DEPARTMENT OF PUBLIC WORKS  
COUNTY OF HUMBOLDT

LAND USE DIVISION INTEROFFICE MEMORANDUM

**RE:** SUBDIVISION REQUIREMENTS - IN THE MATTER OF THE  
APPLICATION OF BRIGHT VIEW HOMES LLC, APN 510-121-026, PLN-  
2023-18247 FMS APPROVAL OF A TENTATIVE MAP, CONSISTING OF 1.6  
ACRES INTO 7 LOTS

**DATE:** 08/08/2014  
10/08/2015 revised  
12/03/2015 revised by Planning Commission  
09/06/2023 revised by Public Works

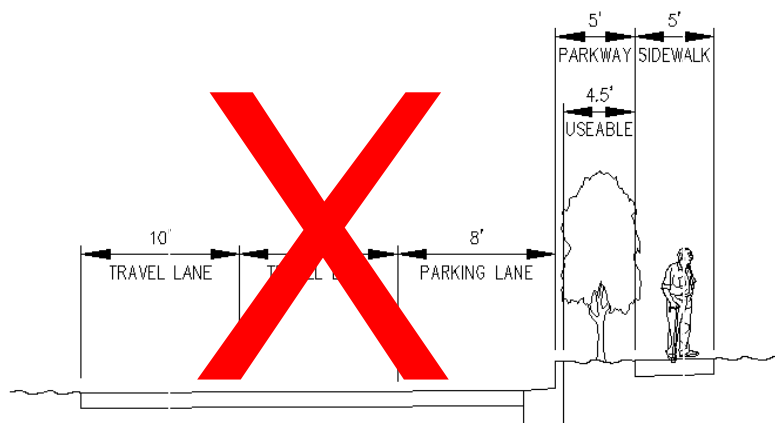
A stop sign will be required on Midtown Court at its intersection with Railroad Drive.

In addition, pursuant to County Code Section 323-2(c)(4), non-county maintained roads shall be posted with a sign of at least 2 square feet in size containing substantially the following words in 2" high black letters on a yellow background: "Not a County Maintained Road" or "Not a County Maintained Street". The sign shall be approved by the Department prior to installation.

~~*Above: Typical Section for Midtown Court*~~

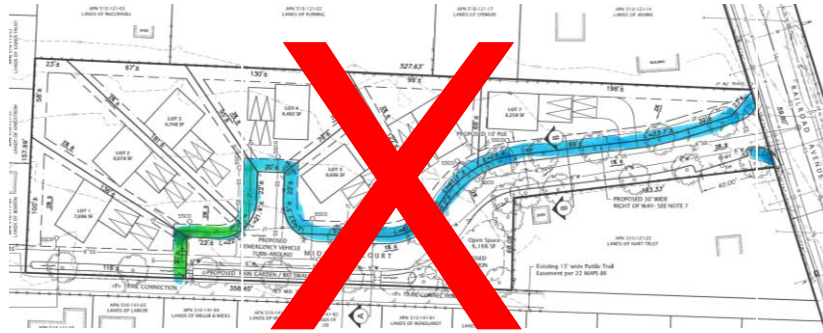
- (b) ~~**MIDTOWN COURT (Not County Maintained):** Midtown Court shall be constructed having a typical section comprised of two 10 foot wide travel lanes, an eight foot wide parking lane, a PCC Caltrans Type A1-6 curb [or APWA A3-150(6) curb], a 5 foot wide landscape strip (4.5 feet useable); and a 5 foot wide PCC sidewalk. The parking lane, landscape strip and sidewalk shall be located on the east side of the road. The sidewalk shall be constructed along the east side of the road from as shown on the tentative map ends at Lot 2; the sidewalk shall be extended to the southwest to connect to the Midtown Trail. The turn around and west side of the road shall be signed/stripped for "no parking".~~

~~The road is proposed to be cross sloped to the west to drain to the storm water detention basin. A Caltrans Type A2-6 PCC curb and gutter may be needed along the west side of the road from Railroad Drive (County Road No. 4M020) to the storm water detention basin.~~

**(b) MIDTOWN COURT (Not County Maintained):** Midtown Court shall be constructed having a typical section comprised of two 10 foot wide travel lanes. The road shall be widened to be 26 feet in width for the first 50 feet; then taper down to 20 feet. The road (including the turn around area) shall be signed/striped for "no parking". The road is proposed to have a tilt section.

*Above: Typical sections for Midtown Court (Alternate)*

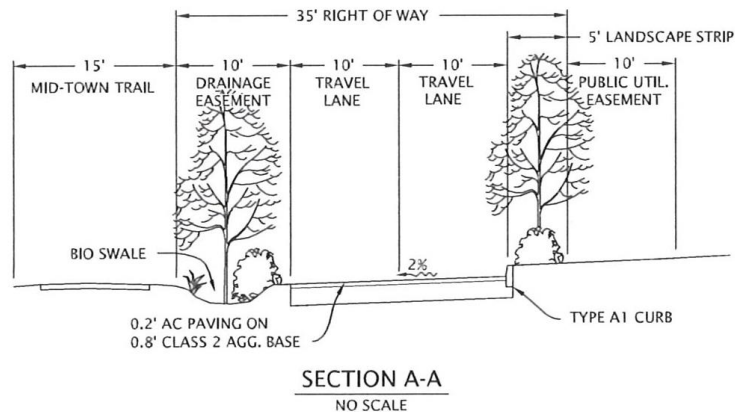
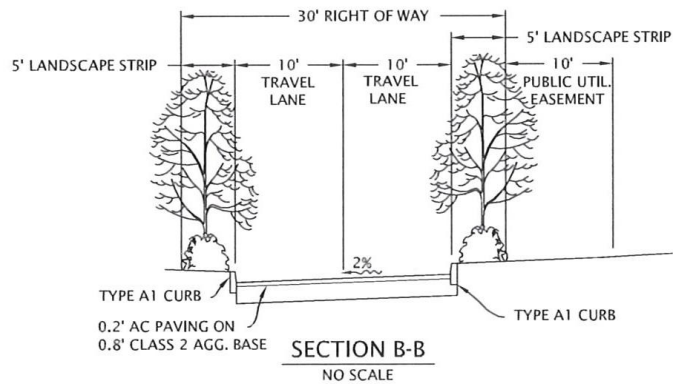
The road is proposed to be cross sloped to the west to drain to the storm water detention basin. A Caltrans Type A2-6 PCC curb and gutter may be needed along the west side of the road from Railroad Drive (County Road No. 4M020) to the storm water detention basin.

*Above: diagram showing the 26' wide road at the intersection of Railroad Drive*

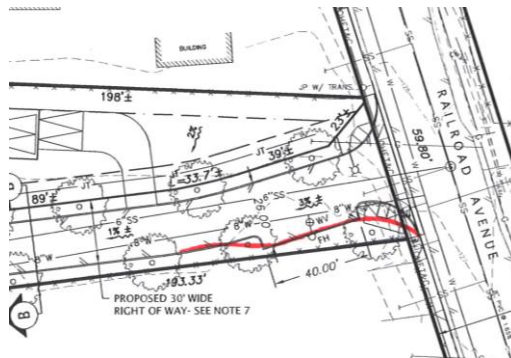
The applicant's agent has advised the Department that since no parking is to be provided, the A1 curb shown on the uphill side of the road may not be necessary.
